NRC Response – 2.11.19

Following the recent Concept Site Plan Presentation by Northland on Dec. 5th the Milton Historical Commission would add the following comments:

Wolcott Woods – Northland Residential – February 14, 2019

#42

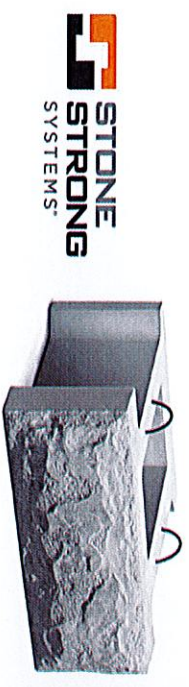
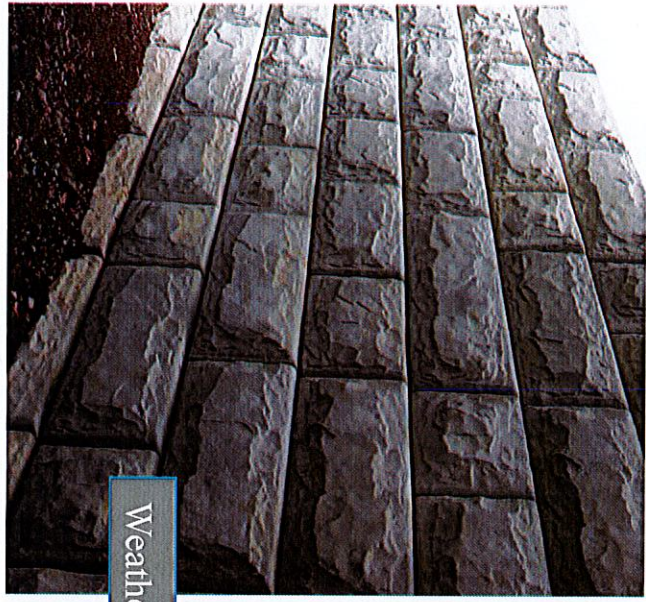
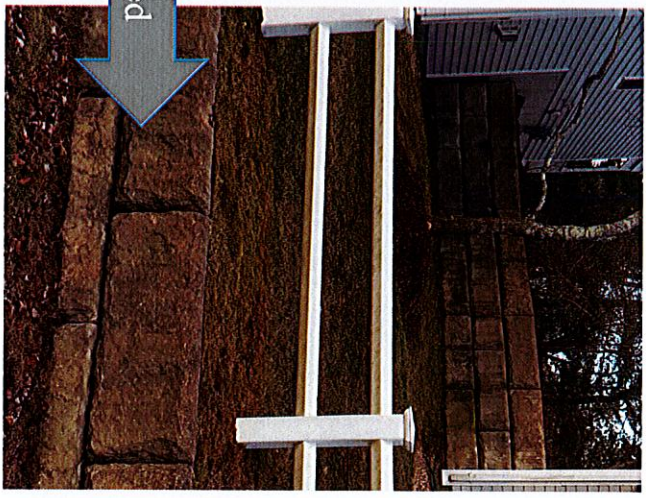
Stone Walls· Stone walls should be consistent throughout the property, including retaining walls and stone facade on new townhomes, and reflect the granite stone walls dominant on terrace and patio and steps of Manor House. There should be a sample mock-up of wall to ensure high quality materials will be used throughout. We would suggest rather than wood guard rails, that a stone-faced wall would be more attractive and historically appropriate. Retaining walls should be a maximum of 4 ft.

- Edge of road retaining wall @ buildings 26-28 & Wolcott House
 - Unit specific landscape grade change walls
- At the intermittent stream crossings, think bridge like condition, a structural retaining wall, which embraces the road crossing and culvert below is required. As this face is not visible from the street, we proposed to use a stone faced manufactured interlocking structural block wall to satisfy the structural and culverting requirements of the crossings. Use of a rock faced interlocking large block wall provides the necessary long term structural support to support the roadway and associated underground infrastructure at each respective crossing. We have used this approach in a similar application at our Belmont project with great success and found that the weathering of the rock faces allows the retaining wall to disappear into the forest palette – see attached Slide #42.

#25

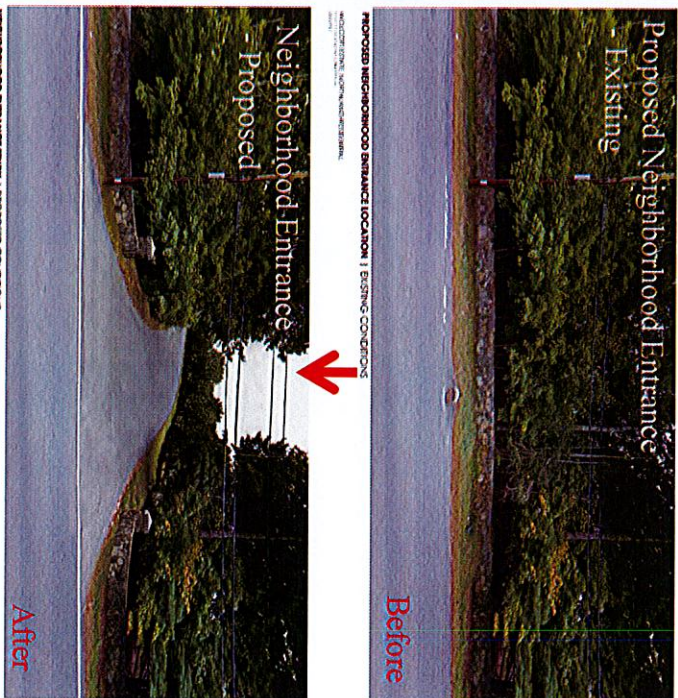
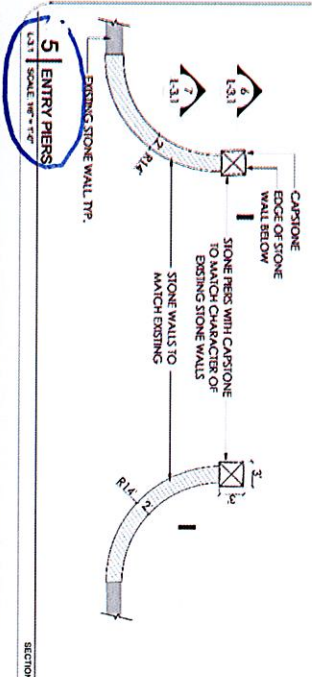
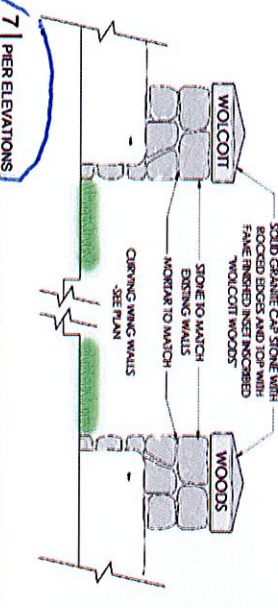
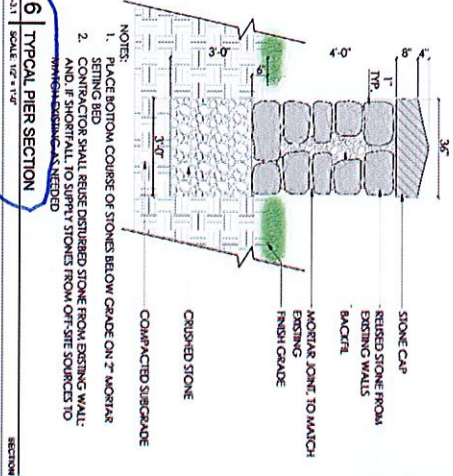
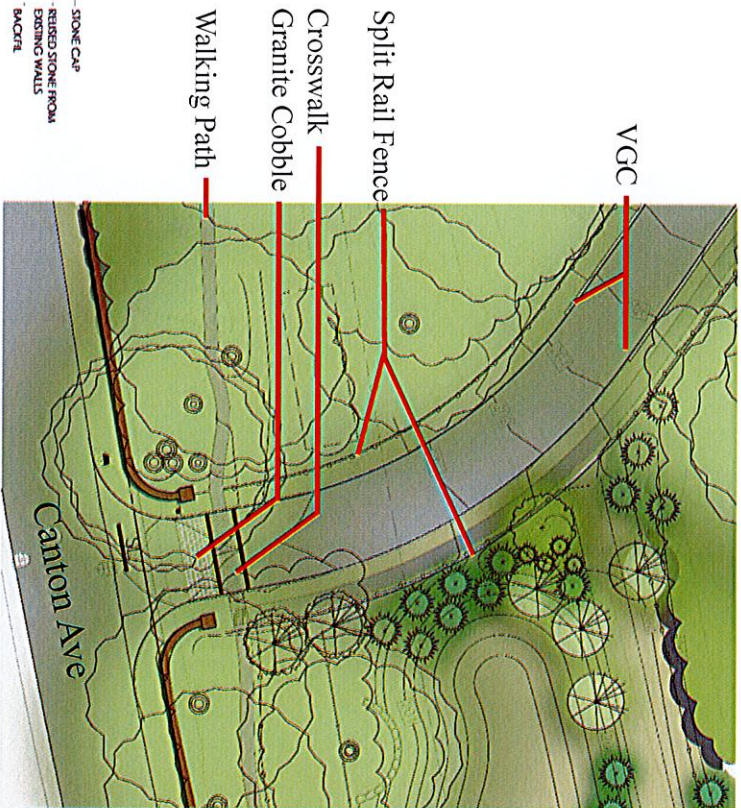
New stone entrance to Manor House should mirror existing entrance, materials, height and scale and stonework, including repainting should be done by someone experienced in repairing and replacement of historic stone walls. Location and size of the entrance opening should be marked and approved by the Planning Board and MHC prior to removal of the existing stone wall.

Signage – Signage at entrance should be appropriate for a historic property and setting, and subject to design review by the planning Board and MHC.

- The location and size of the new opening @ Canton Ave is depicted on Slide #25.
- The new Wolcott Woods Lane entrance will require the cutting in of a new 34’ opening within the existing wall. The removed stone material will be stockpiled in order to create a new flared stone wall entry terminated by capped stone pillar – see attached Slide 25, details # 5,6 & 7.
- The remaining stone material will be used to connect (fill in) the stonewalls at the abandoned and filled-in existing 37’ wide middle entrance drive opening – see Slide #24.

- Entry signage is depicted on Slide #25

#41

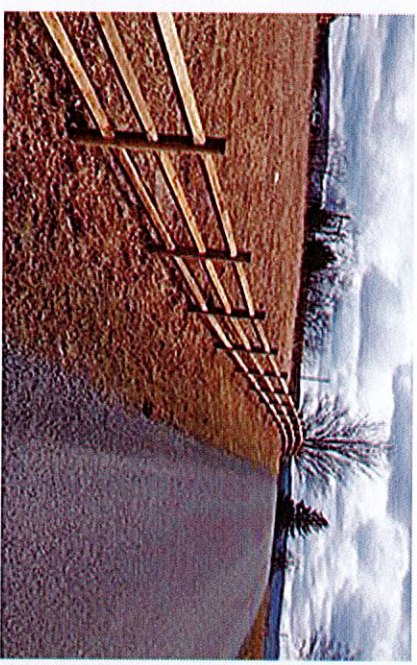
Fencing - Split rail fence in natural wood finish, which has recently been removed along the meadow and Devens House drive, should be replaced in its original location and staked to mark its original location as best possible, prior to initial construction in order to retain the property's original agricultural character.

- The present plan set provides for a wooden 3 rail split rail fence extending from the new entry stone pillars along both sides of the new entry road to the mail-box building parking area on the right and to the access driveway of unit # and along the Canton Avenue side of the open drainage basin – see Slides #41, 40 & 30 for fence detail.

Site Planning – Updates: Meadow Basin Fence

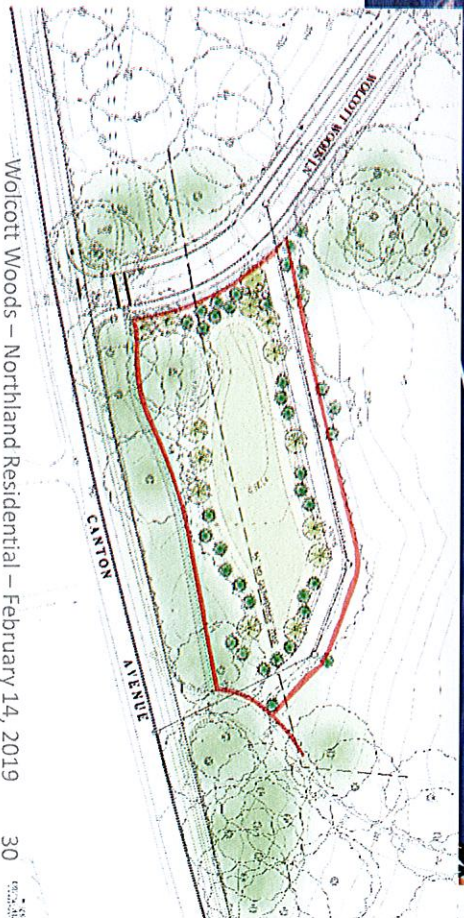
Retention basins – Should not be place within the no-touch buffer zone and should be paced in the location where natural basin currently exists below the meadow and designed such that a splits rail and vinyl chain link fence is not necessary, significantly altering the historic and scenic Landscape. This should be done by an independent engineer aware of such topographical contours and seeking to utilize existing conditions and minimize cut and fill proposed in open spaces preserving the historic landscape.

- A drainage basin is required to manage stormwater from the new entry road up through the mail station. The basin, as designed, comports with the bylaw and it is located in an existing low topographic depression behind the stone landscape wall boarding Canton Ave – See Slides 39. The split rail fence was a request of the Planning Board in conjunction with a request to extend the Canton Ave walking path along the entire frontage – See Slide #30.
- An independent engineer, retained by the Planning Board, has conducted a full review (*and has signed off*) of the Project’s storm water (drainage) design, inclusive of the placement of drainage improvements and their compatibility with existing topographical contours.

#6

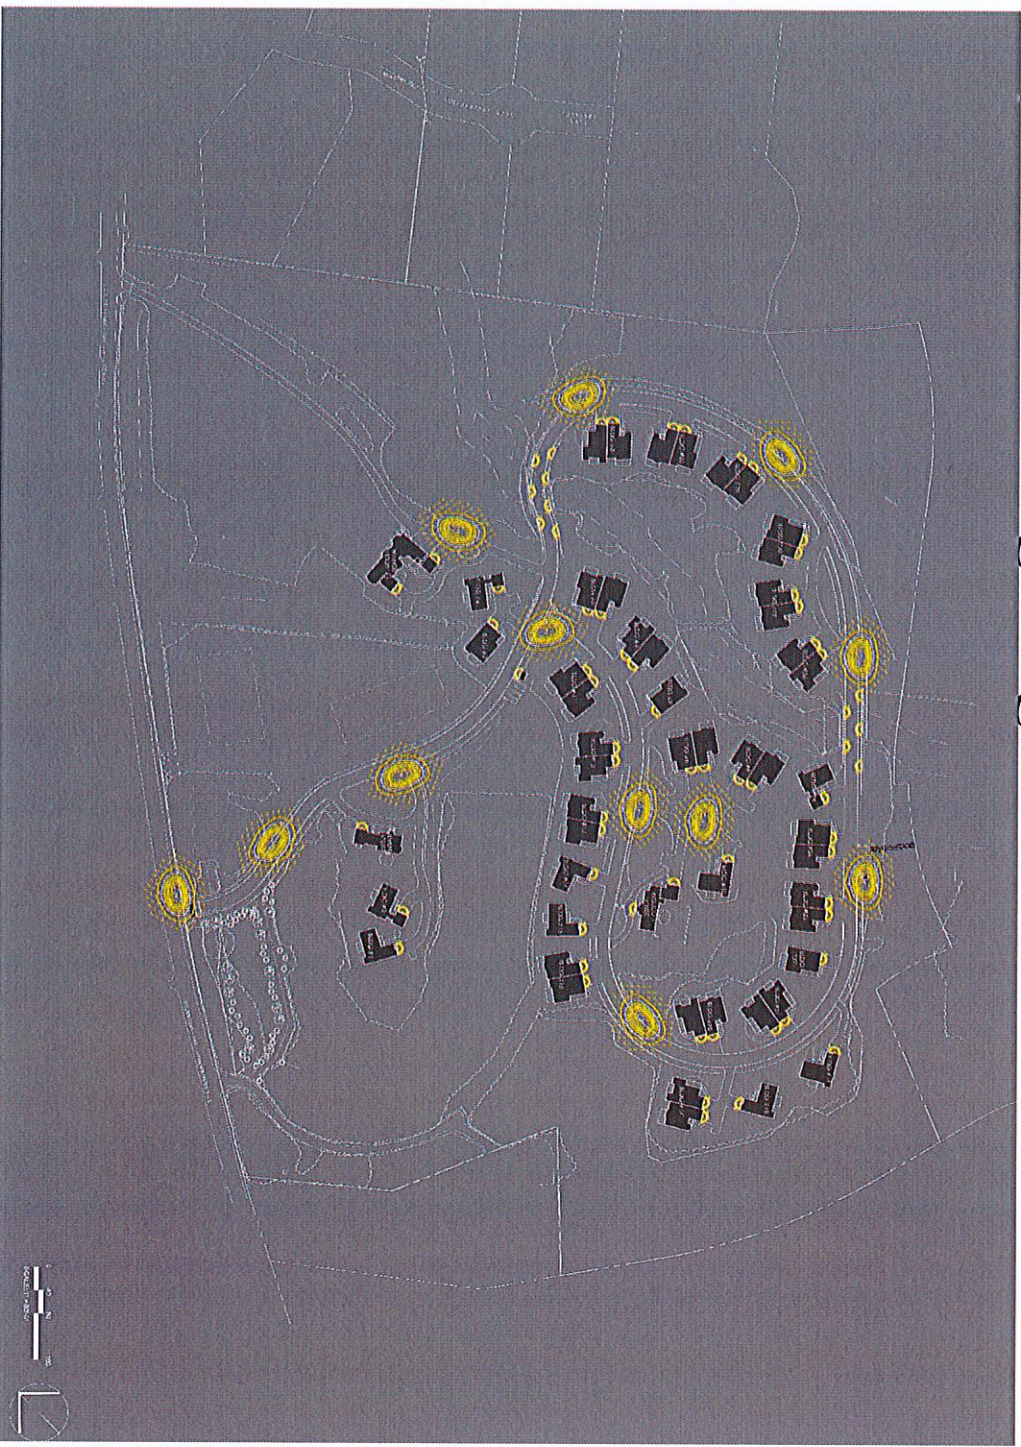
Landscape – The front lawn of Manor House and Meadow should be fenced during construction and no cut of fill to be made in these. This should be the case for upper fields and tree groves to be preserved. A peer review by a naturalist to identify all significant trees. An alley of trees at drive entrance should be created to preserve the Great Estate entry.

- The Development Team includes Tree Specialists Inc., a certified arborist, who in concert with the Developer, Jack Dawley, its engineer, Deb Keller, and Landscape Architect, Alan Aukeman, repeatedly walked, surveyed and recorded all significant ‘at risk’ trees or groves of trees. The proposed site plan incorporates this work, data and a sensitivity to and of the landscape in it’s the development. The Tree Preservation and Protection Plan and Open Space Plan have been shared with and reviewed by the Shade Tree Advisory Committee as required by the Bylaw – See Slide # 6.

#48

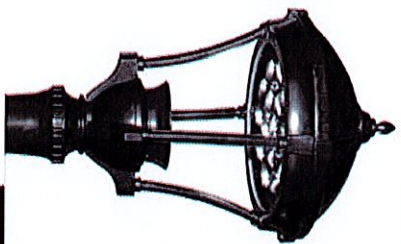
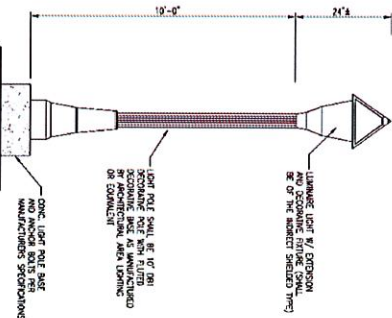
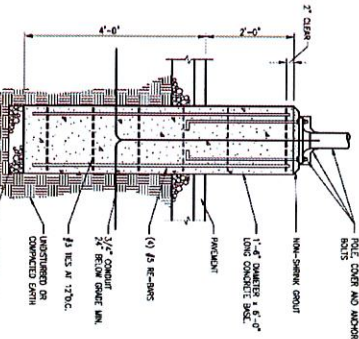
Lamp posts – Proposed lower height lighting proposed by develop is recommended to minimize light viewed from Canton Ave to 128.

- The application, *as submitted*, proposes a 12’ street light height – See Slides # 47 & 48.
